## Combined point-by-point reply to the comments

Iteration: minor revision

# Uncertainty quantification of flood mitigation predictions and implications for interventions

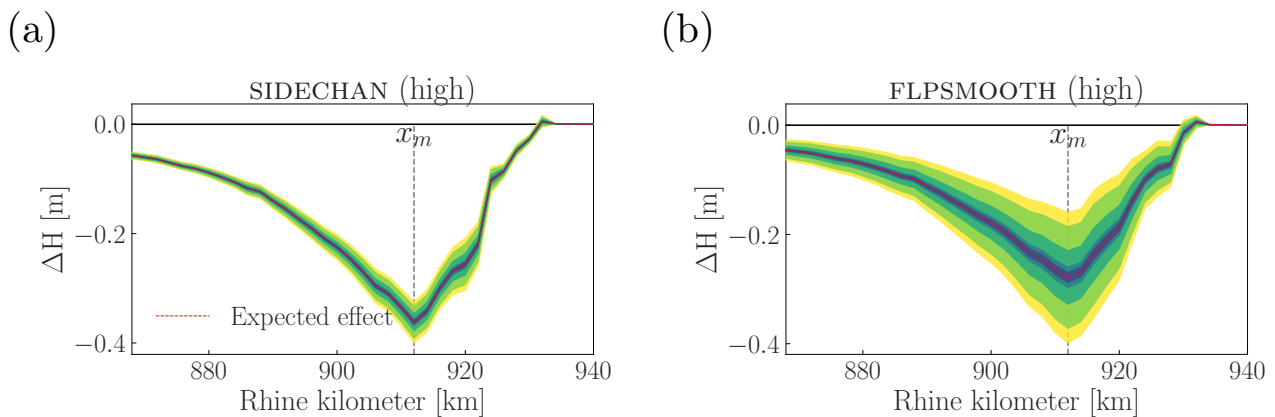
p14 "The novelty of Fig. 6 these results" -> "The novelty of the Fig. 6 results"

All above suggestions have been adopted in the revised manuscript, as well as other small changes after a further proof-read.

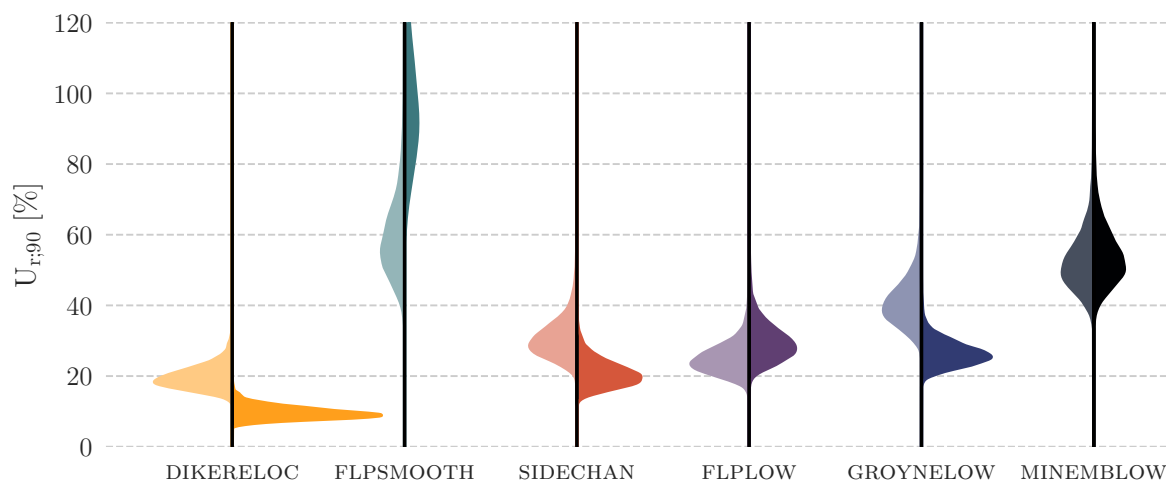
[R2.2] I struggle with the interpretation given by the authors of figure 8. You write that MINEMBLOW and FLPSMOOTH are most uncertain. I guess this has to do with the bandwidth of outcomes covered by the densities in figure 8. However, based on visual comparison, the difference between MINEMBLOW and GROYNELOW seems to be quite marginal. So how did you arrive at this statement and might it be possible to annotate figure 8 in such a way that it becomes easier for the reader to come to the same conclusion?

The referee states that the differences between MINEMBLOW and GROYNELOW are marginal when compared visually. We stated [p16 L3]:

Indeed, we did not specify how we arrived at that conclusion. Therefore we modified this line to the following:

“In general we observe that flpsmooth and minemblow are more uncertain than the other four interventions. This can be seen by their higher values for  $U_{R;90}$ , especially for the high-intensity variants. We also observe that (...)”
